Review of ETSA Utilities' revised regulatory proposal for the period July 2010 to June 2015

May 2010

for the Australian Energy Regulator

Figure 2.1 Unplanned lines expenditure by category (real 2008) – original proposal

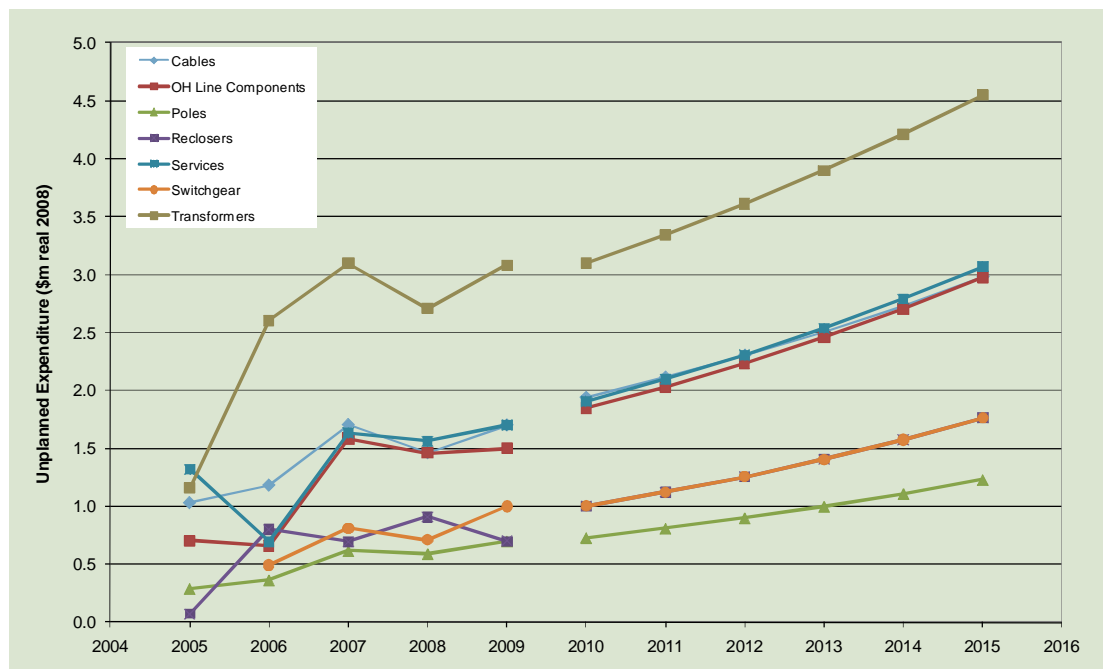
As shown in Figure 2.1 ETSA Utilities' assumption of a relatively consistent annual expenditure growth rate over the next period is not supported by the expenditure history at an asset category level over the current period.

Therefore PB considers that the assumed linear growth in unplanned lines expenditure is not supported by ETSA Utilities failure and expenditure history over the current regulatory control period. PB is also concerned that the historical expenditure is influenced by ETSA Utilities' recent adoption of targeted inspection cycles for distribution line assets. Furthermore the application of a high level capex forecast without reference to the failure history or the known condition of assets as proposed in ETSA Utilities revised forecast is not supported and inconsistent with the capex estimating methodology used for the remainder of the capex proposal. On this basis PB recommends that the original adjustment applied in the AER draft decision is retained, as shown in Table 2.5.

Figure 2.2 Transformer expenditure (real 2008) and failure history – original proposal

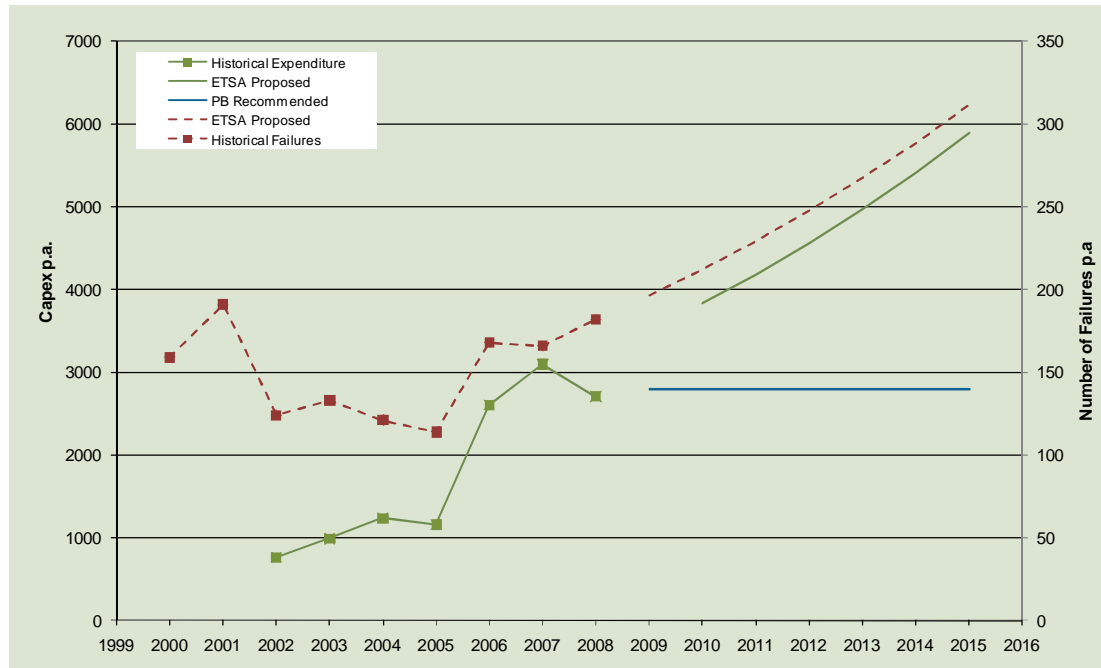
Due to the materiality of the transformers category in the original proposal and the recent step changes that have been observed in most categories, PB considers that ETSA Utilities assumption of continued expenditure growth is not supported and that there is a reasonable basis for expecting that ETSA Utilities' future capital expenditure on unplanned line components may remain constant or return to historical levels over the next regulatory control period as targeted maintenance practices and capacity augmentations address the assets at highest risk of failure due to condition or insufficient capacity.
